Subdivision Authority

File No. LDA10-0386

RE: Tentative plan of subdivision to create 36 semi-detached residential lots, one (1) medium density residential lot and two (2) Public Utility lots from SE 19-53-25-4, located south of 137 Avenue and northwest of Trumpeter Way; **TRUMPETER**

## SUBDIVISION CONDITIONS OF APPROVAL MAP

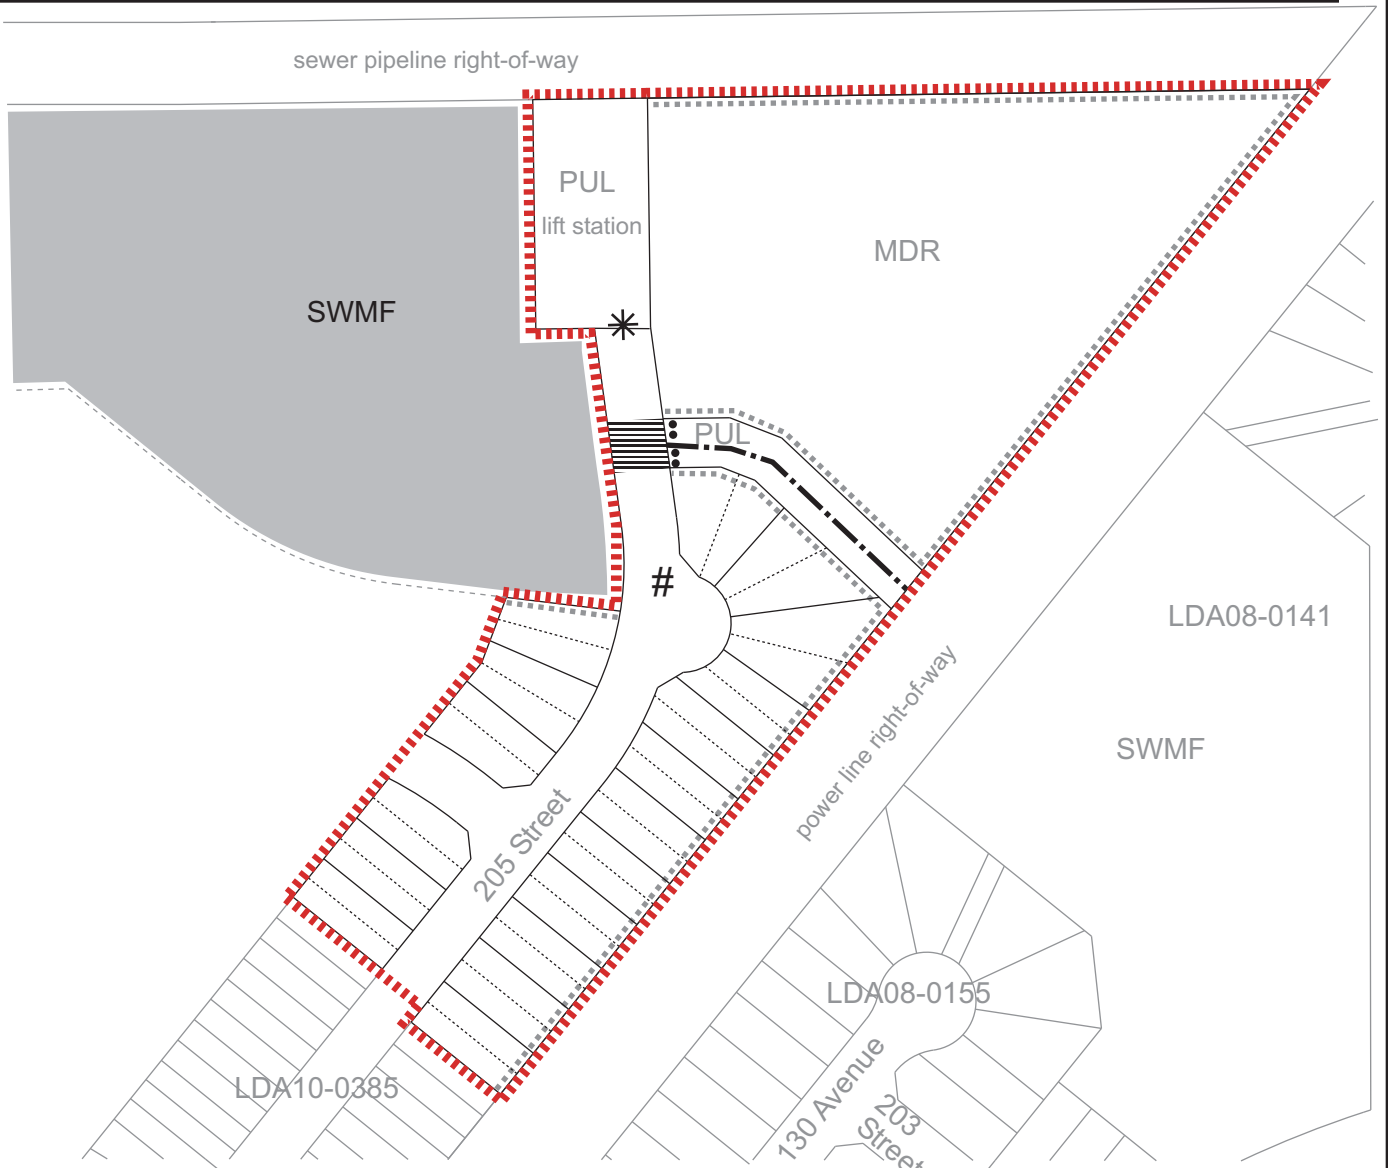
9. that the owner construct a 2 m granular shared use path within the Public Utility Lot (PUL) to connect with the 3 m shared use path located within the power line right-of-way, as shown on the "Conditions of Approval" map, Enclosure I;

10. that the owner provide a zebra marked crosswalk with curb ramps and pedestrian signage at the mid-block crossing as shown on the "Conditions of Approval" map, Enclosure I;

11. that the owner install "No Exit" signage along the north/south local road, in the vicinity of the bulb to be used as a turn around, as shown on the "Conditions of Approval" map, Enclosure I;

12. that the owner construct a 6 m commercial crossing to the Public Utility lot, as shown on the "Conditions of Approval" map, Enclosure I;
13. that the engineering drawings include the details of the existing crossing as shown on the "Conditions of Approval" map, Enclosure II. The crossing must be inspected by Transportation Services - Development Engineering by May 30, 2012 to determine if reconstruction is required. If reconstruction is required, the engineering drawings must include the reconstruction;

14. that the owner construct all fences positioned wholly on privately owned land as shown on the "Conditions of Approval" map, Enclosure I; and
15. that the owner is responsible for the design, landscaping and construction within the Public Utility lots, utility right-of-way, road islands, boulevards, medians, walkways and Municipal Reserve parcels, to the satisfaction of Sustainable Development, Transportation Services and Infrastructure Services.

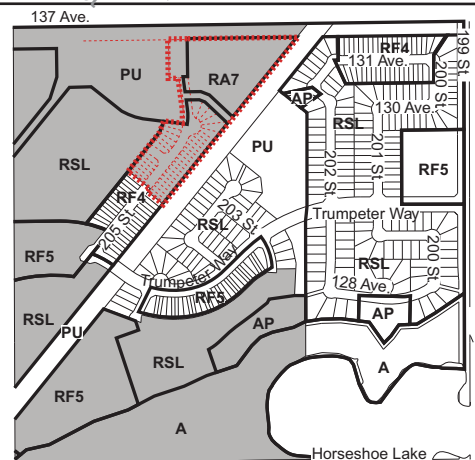
8. that the engineering drawings include signs at both ends of the private temporary secondary access road clearly stating that the roadway is temporary and privately owned, in the locations shown on the "Conditions of Approval" map, Enclosure II. The signs are to be installed within six months of the signing of the Servicing Agreement, to the satisfaction of Transportation Services;
